| REV. | DESCRIPTION | MODIFIED BY | DATE |  MINNETONKA, MN | | SNAPRAILMINI | | | | |
| | | | | | | | DRAWING NO. | EP2953 | REV | B |

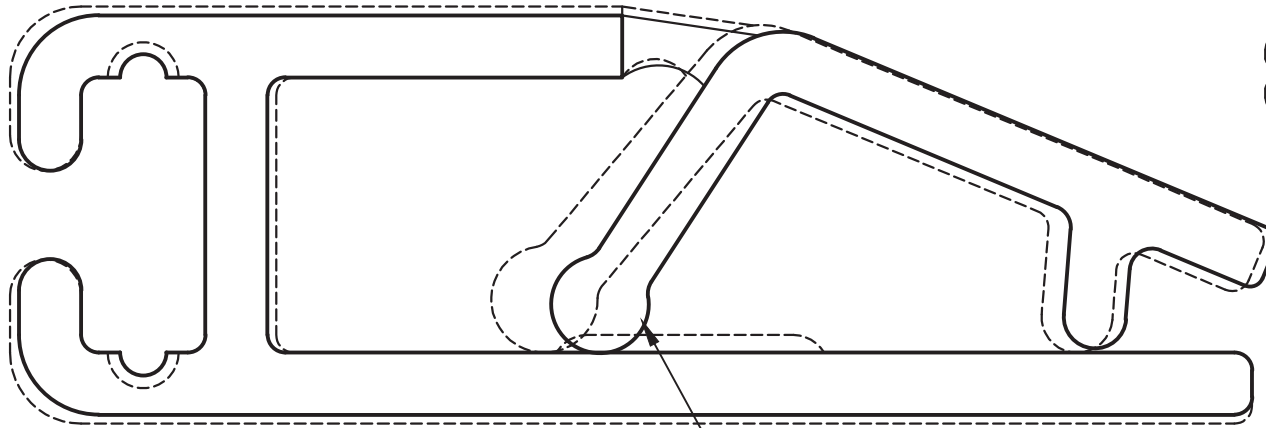
Dotted lines represent previous design.
Solid lines represent proposed new design.

- 1) Wall was .040" / Now .035"
- 2) Hinge is now .015" longer and .005" thinner
- 3) Rotated "pinch leg" 7° and shortened by .012"
- 4) Removed gripper pad from design
